This Service Information bulletin supersedes SI M17 04 12 **dated October 2012.**

Service Action: Retrofit of the Engine Coolant Temperature Sensor

R60 with manual transmission (N16 or N18 engine)

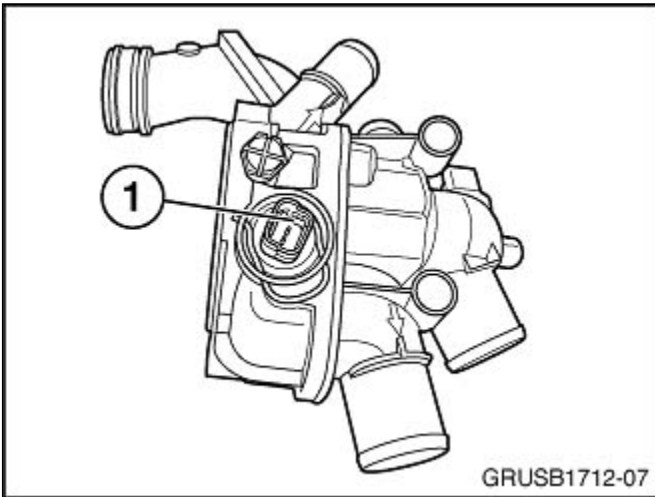
NEW **Procedure One** requires the replacement of the upper coolant hose with a modified hose that houses a new engine temperature sensor. An adapter harness needs to be fitted to the car to utilize this new sensor.

NEW **Procedure Two** requires the installation of a new engine temperature sensor, with integrated wire harness, installed in place of the thermostat bleeder screw.

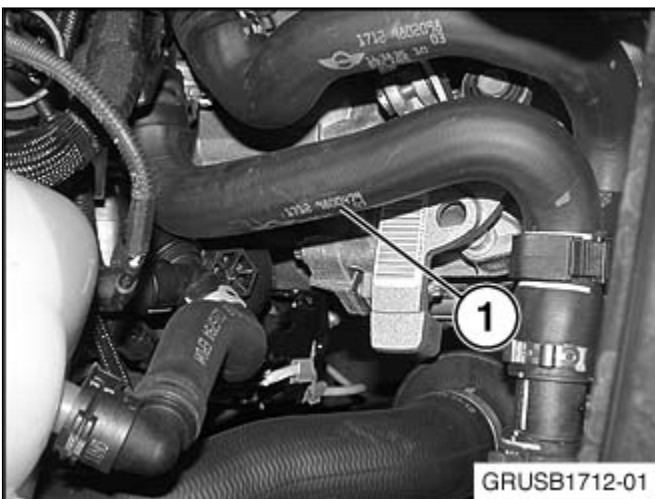
Checking for updated thermostat: The 11 53 7 534 521 thermostat has a replaceable engine temperature sensor (1).

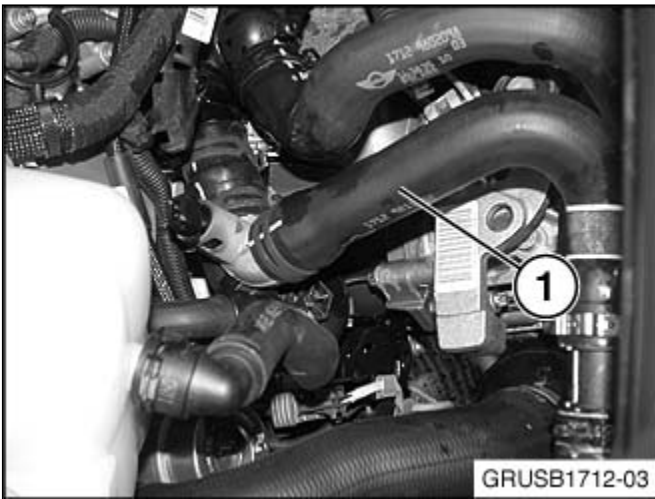
N18 engine only! Install spacer P/N 64 53 7 578 707 (1) on the coolant line as shown.
Note: The spacer needs to stay in this position when installing coolant hose P/N 17 12 9 811 352 (next step).

Install the new coolant hose with sensor P/N 17 12 9 811 352 (1).

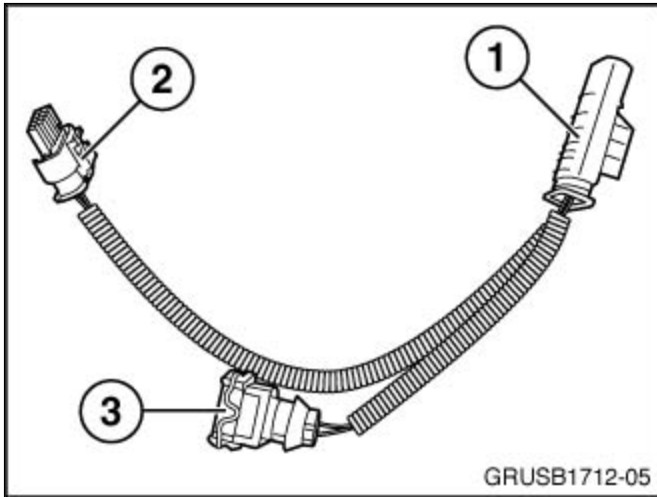
Unplug connector X6279 from the engine thermostat (1).

Plug connector X6279 into the 4-pin male connector (1) of adapter harness P/N 12 51 7 647 200. Insert the 4-pin female connector (2) of the adapter harness into the engine thermostat. Plug the 2-pin female connector (3) from the adapter harness into the engine temperature sensor of hose P/N 17 12 9 811 352.

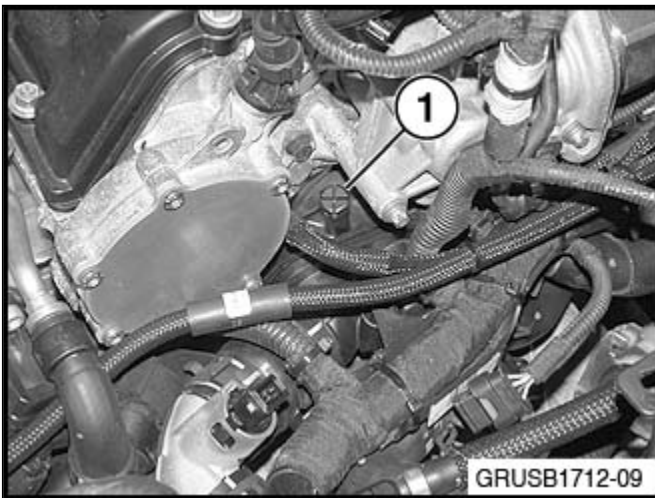
The improved sensor (PN13 62 8 603 908) includes the temperature probe (1) and insulating sleeve (2), a two-pin female connector (3) for the map thermostat and a four-pin connector (4) for the engine harness

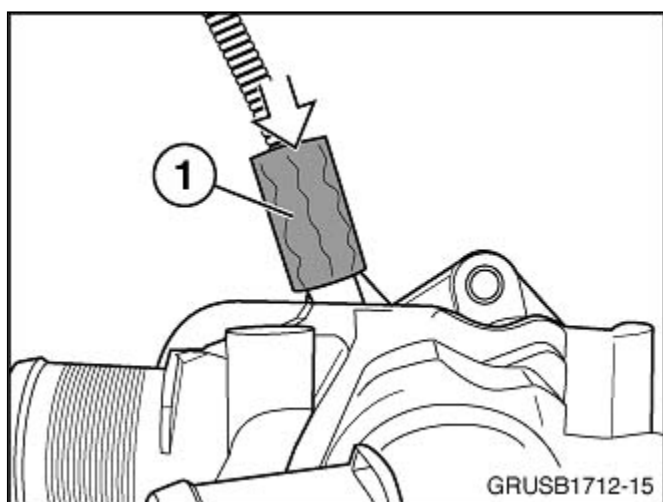
Remove the bleeder screw (1) from the thermostat. This screw will not be reused.

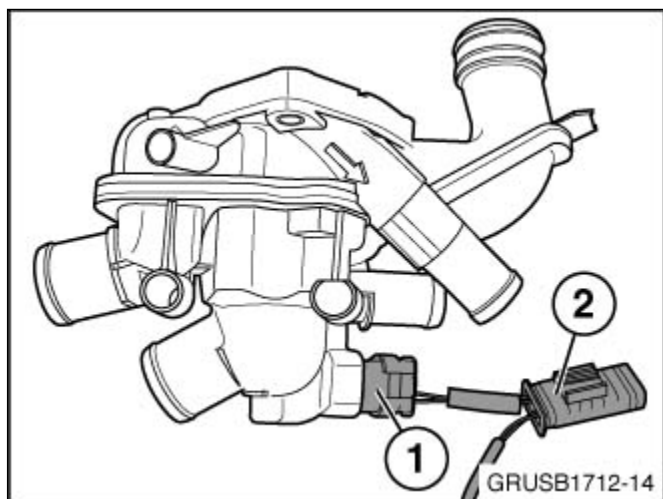
The back of the temperature sensor is slotted to accept a bladed screwdriver (1). Install the sensor into the bleeder screw hole and torque to 2Nm.

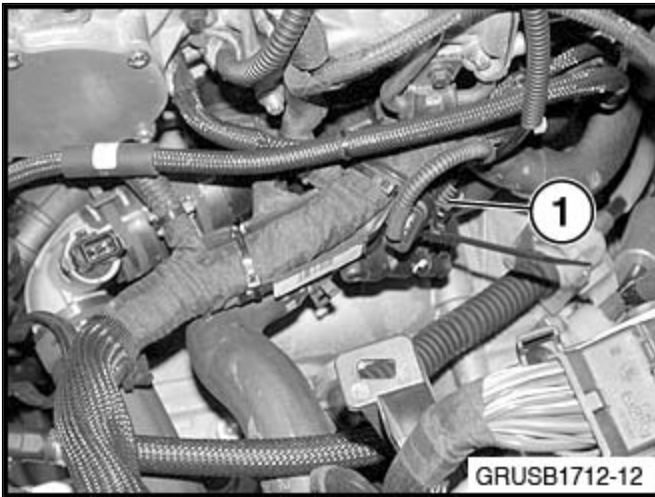
Slide insulating sleeve (1) onto the temperature sensor. The sleeve must completely cover the sensor.

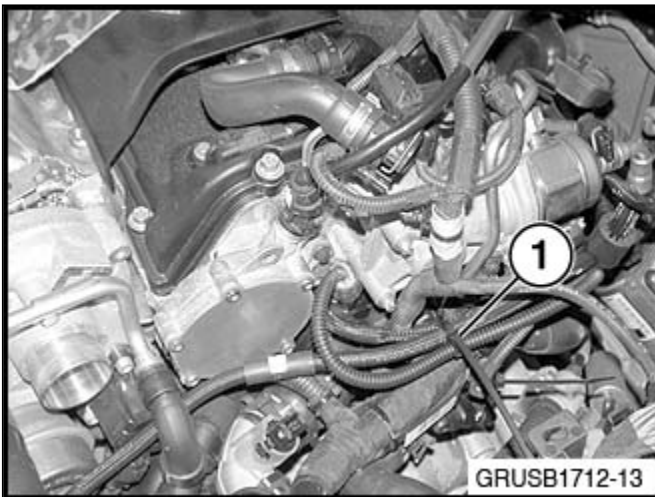
Install the two-pin female connector (1) into the thermostat and the four-pin male connector (2) into the engine wiring harness.
